**Zigmont Rd 12-inch Water Main
Solicitation Number: CO-00536
Job No.: 21-7001**

**ADDENDUM 2
June 16, 2022**

SAN ANTONIO WATER SYSTEM
 ZIGMONT ROAD
 12" WATER LINE
 OVERALL QUANTITIES

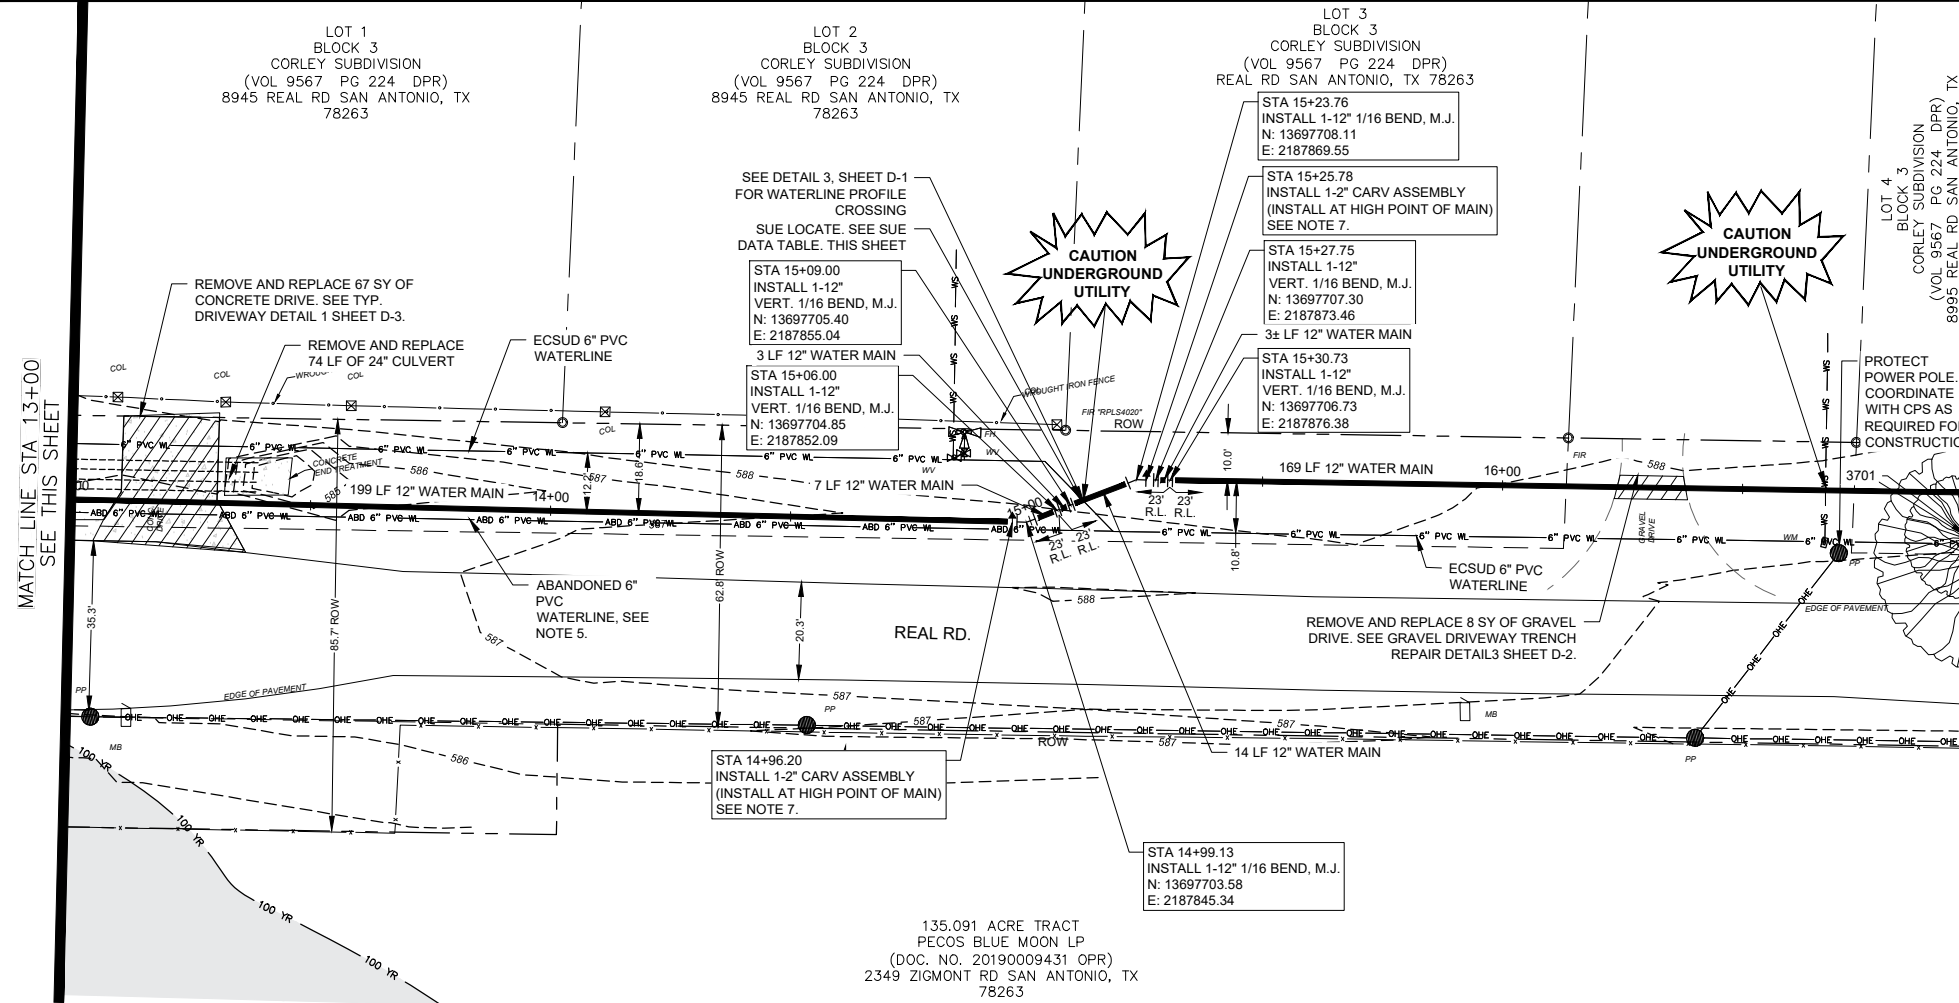
1. Sheet G-4 – Replace entire sheet.
2. Sheet C-1 – Replace the sheet quantity summary table with the following table:

SAN ANTONIO WATER SYSTEM
ZIGMONT ROAD
12" WATER LINE
PLAN SHEET
STA. 9+00 TO STA. 17+00

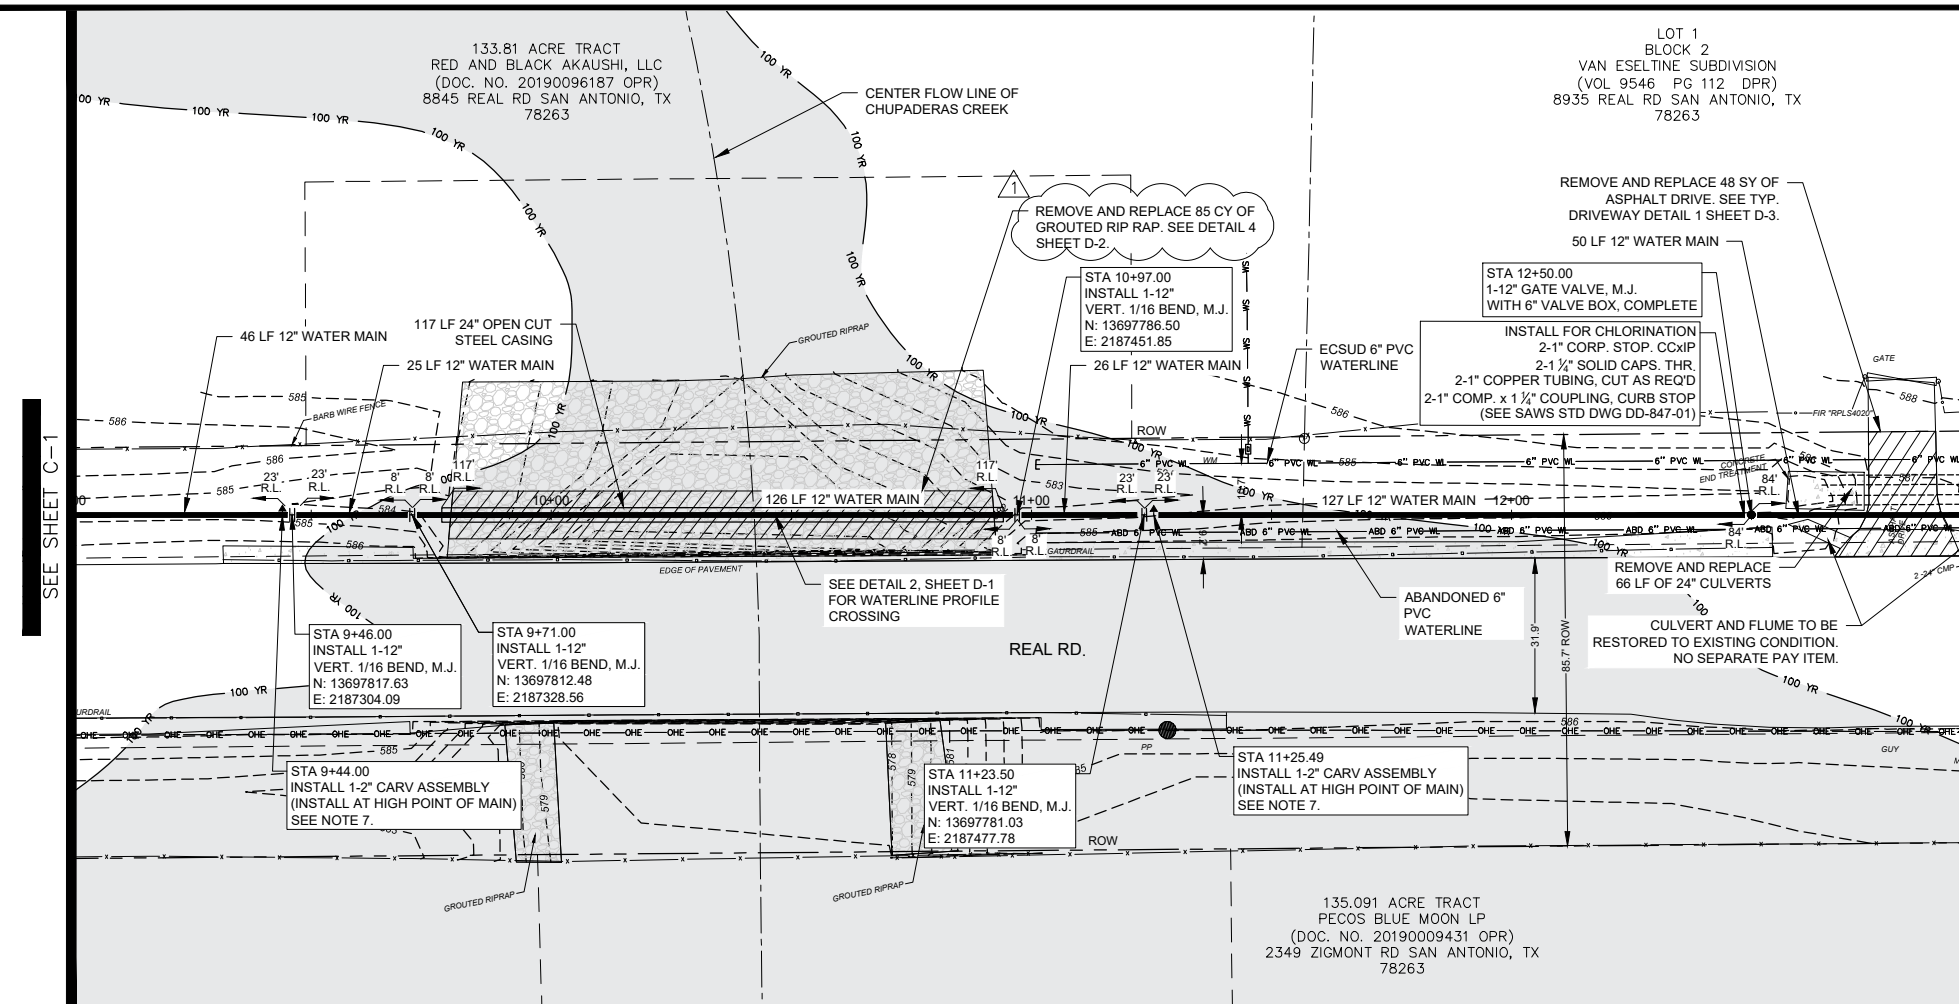
3. Sheet C-2 – Replace entire sheet.
